Bayside Planning Panel

Item No	6.8
Application Type	Development Application
Application Number	DA-2009/316/D
Lodgement Date	22 September 2017
Property	52 Clareville Avenue, Sandringham NSW 2219
Owner	Mrs Anastasia Susan Prapas and Mr Jim Prapas
Applicant	Mr Jim Prapas
Proposal	S96 (1A) Modification Application seeking to reduce lift overrun height, relocation of lift door to east side, addition of a colorbond roof to roof terrace and deletion of Condition 11a
No. of Submissions	Three (3)
Cost of Development	N/A
Report by	Adam Iskander – Development Assessment Planner

Section 96(1A) – Delegated Report

Application Number: DA-2009/316/D
Date of Receipt: 22-Sep-2017
Property: 52 Clareville Avenue, SANDRINGHAM NSW 2219
Lot 13 DP 5643
Owner: Mr J Prapas and Mrs A S Prapas
Applicant: Mr J Prapas
Proposal: S96 (1A) Modification Application seeking to reduce lift overrun height, relocation of lift door to east side, addition of a colorbond roof to roof terrace and deletion of Condition 11a

Shadows Winter Solstice
9am
1 : 200

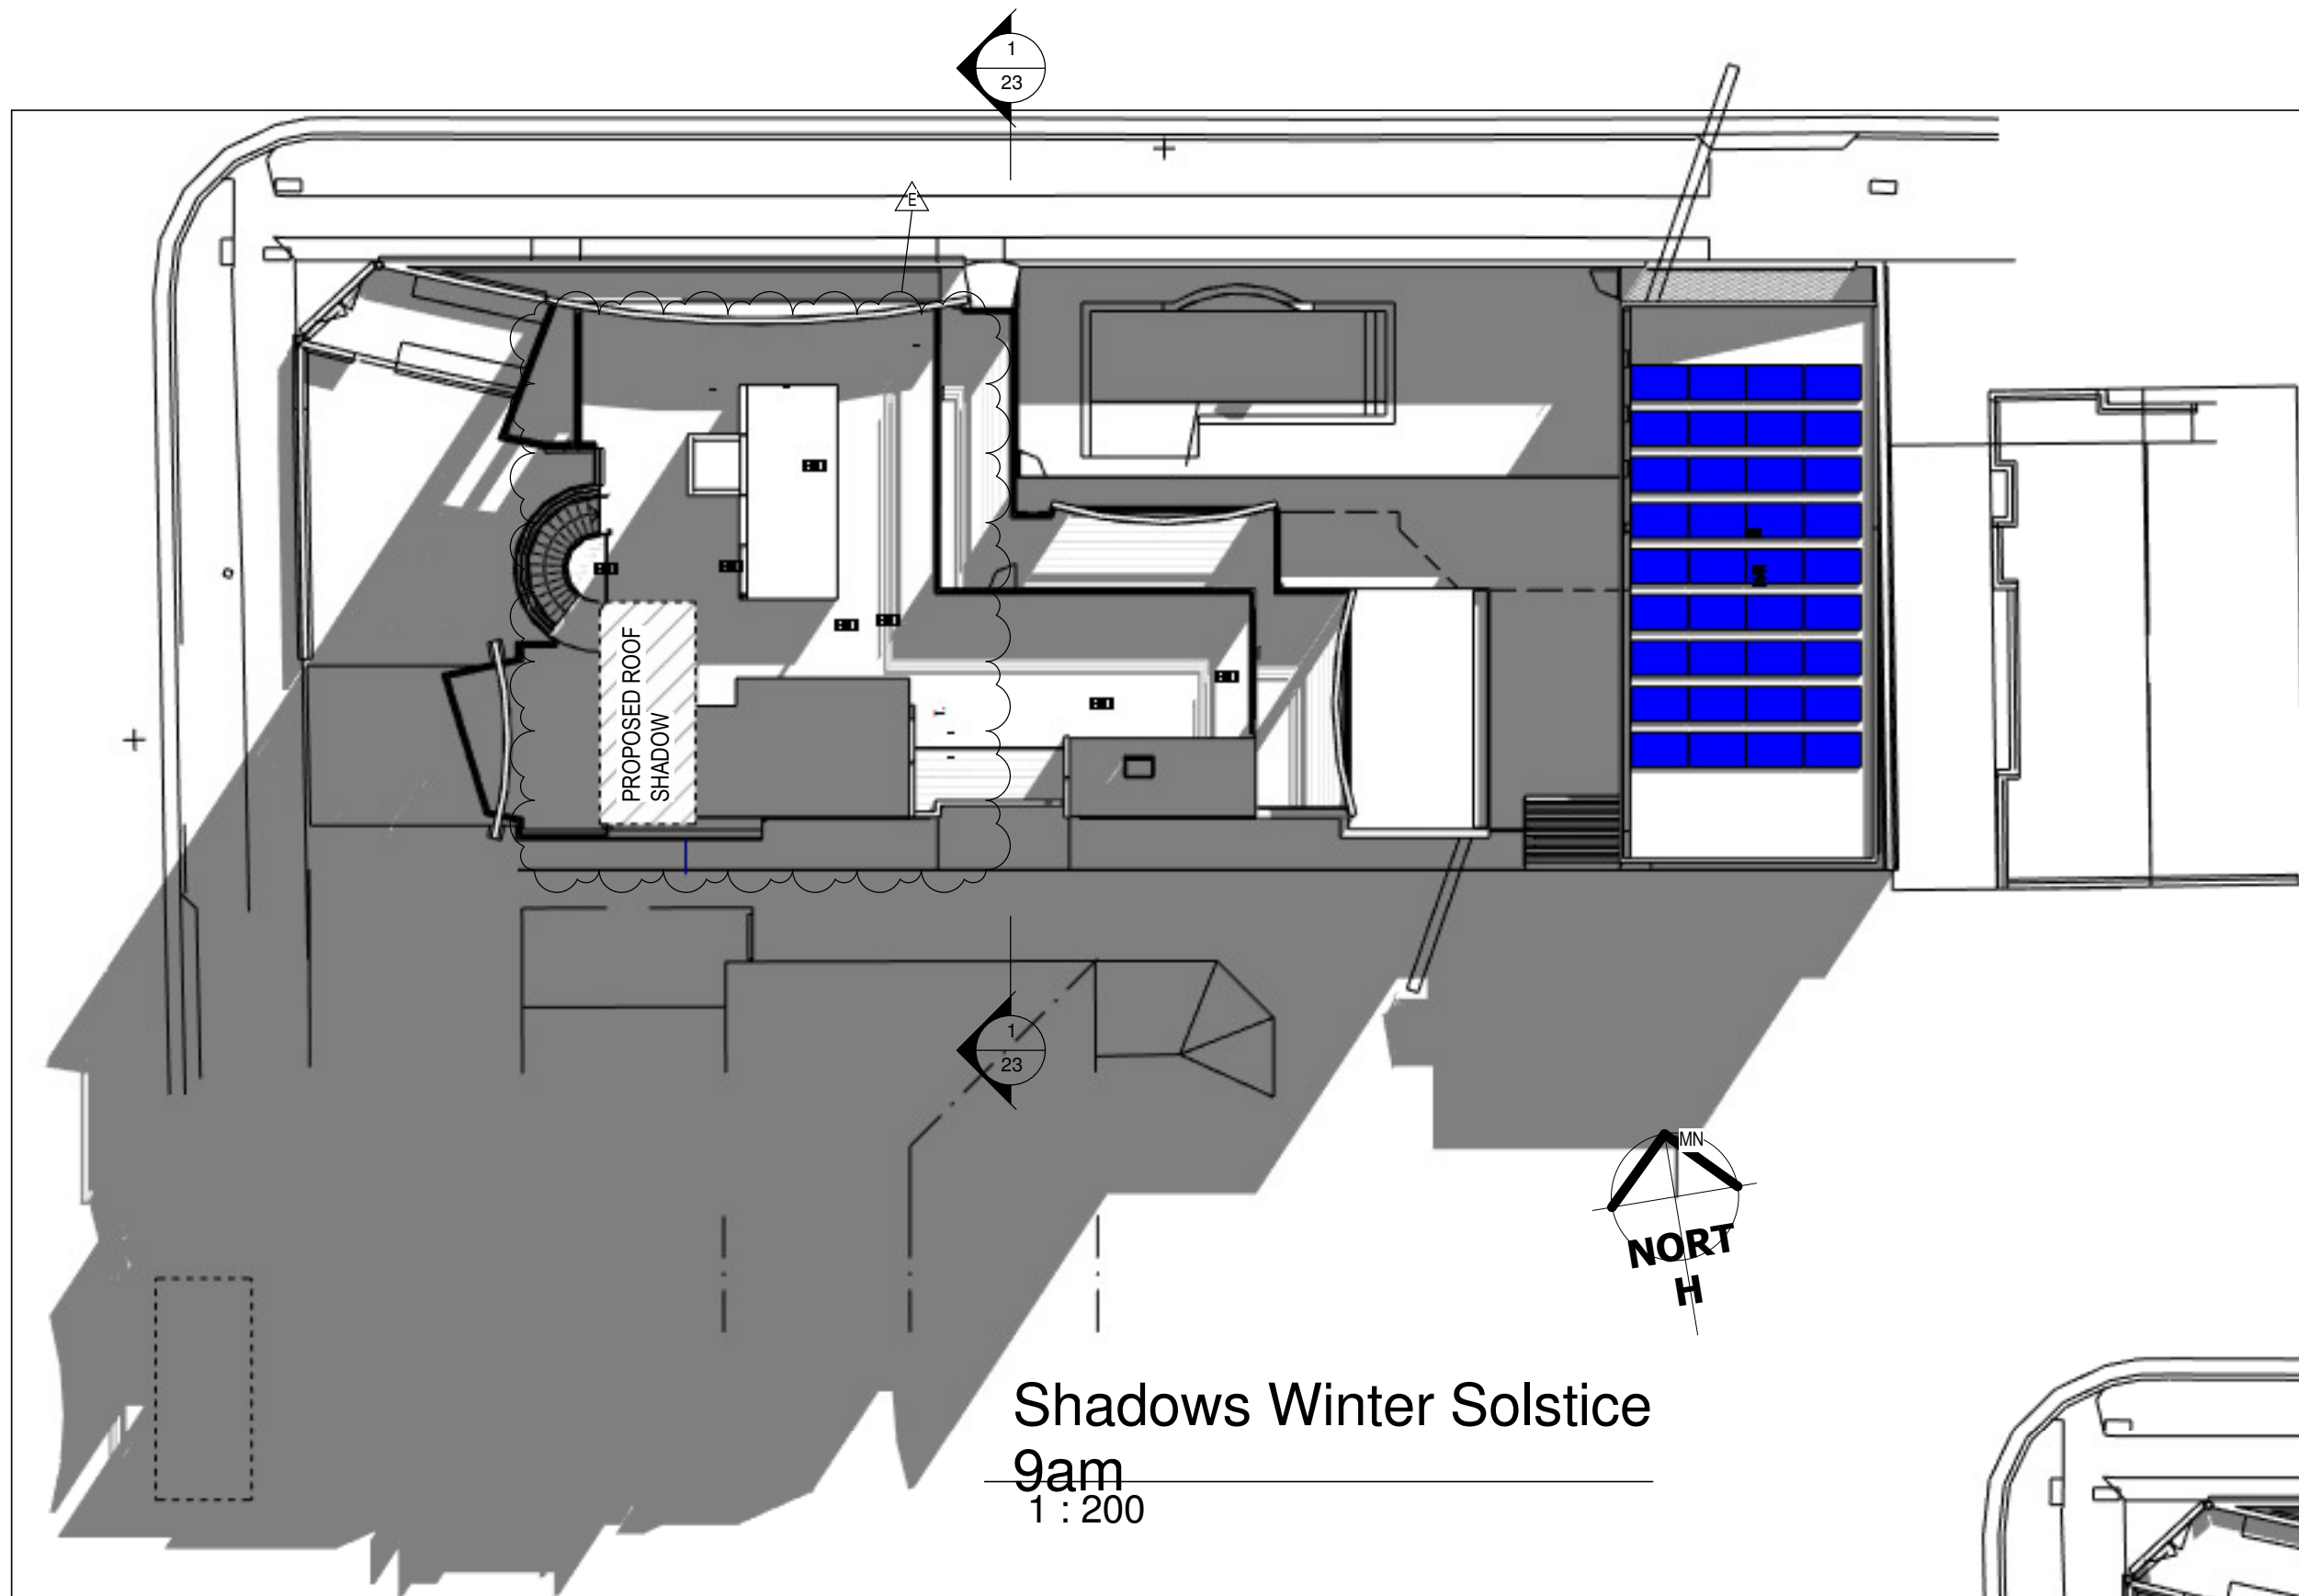
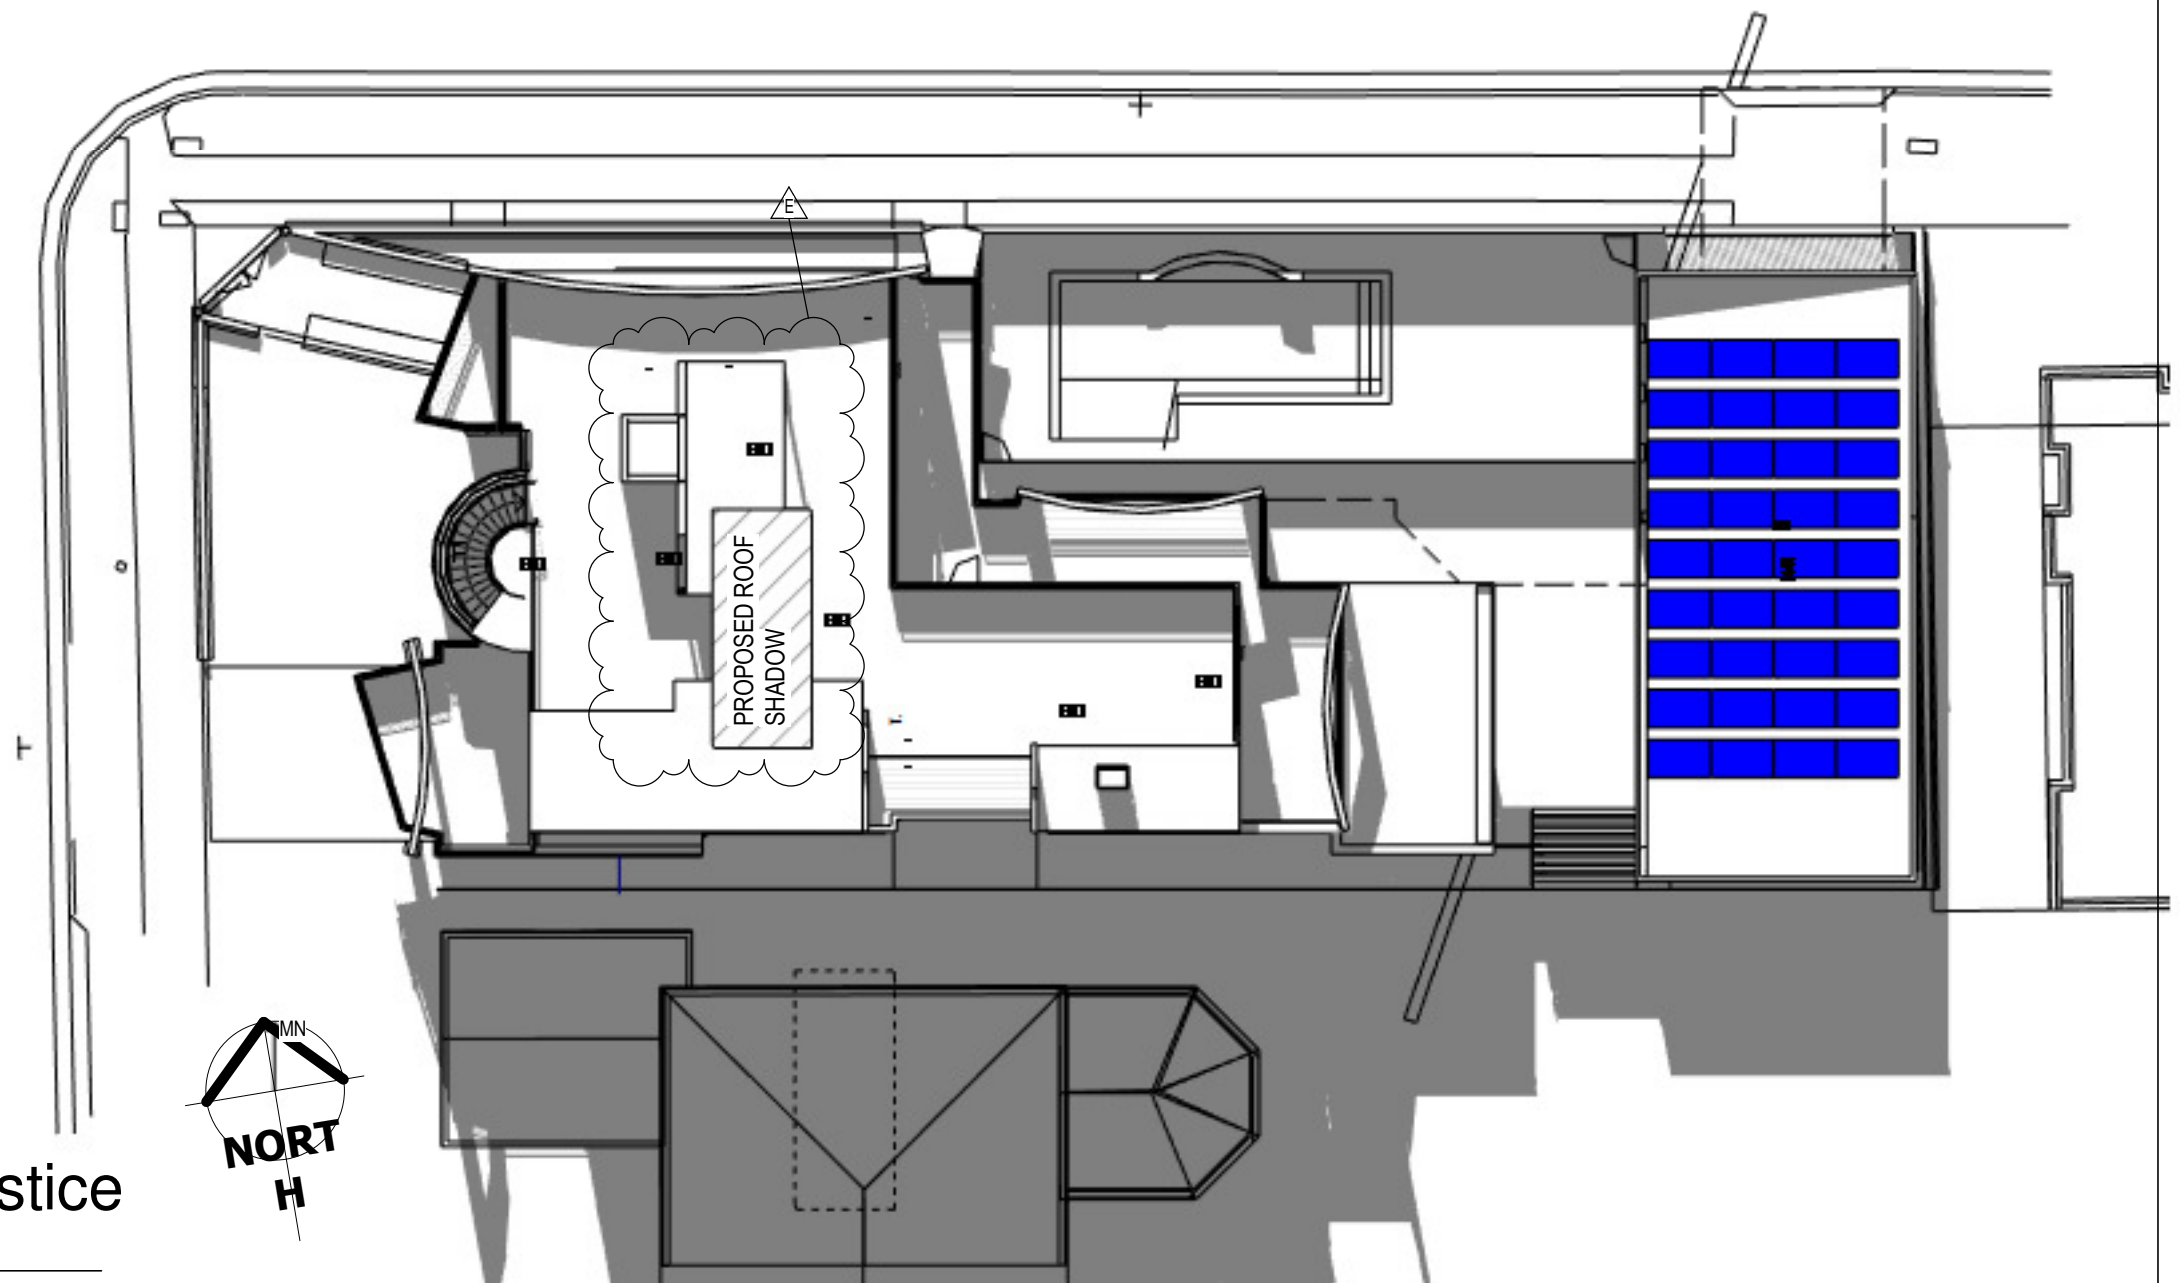
According to the submitted shadow diagrams, the shadows created by the roof top entry point will not cast beyond the building edge, therefore, there will be no additional over-shadowing onto the southern neighbour. The application satisfies Objective B of Part 4.4.2 of RDCP where the proposed works do not unreasonably diminish sunlight to neighbouring properties.

Issue: Insufficient information on the impacts of solar access in mid-summer;

Comment: Council is satisfied with the shadow diagrams provided. The shadows created by the proposed covered area in front of the lift will not cast beyond the building edge, therefore, there will be no additional over-shadowing onto the southern neighbour. The application satisfies Objective B of Part 4.4.2 of RDCP where the proposed works do not unreasonably diminish sunlight to neighbouring properties.
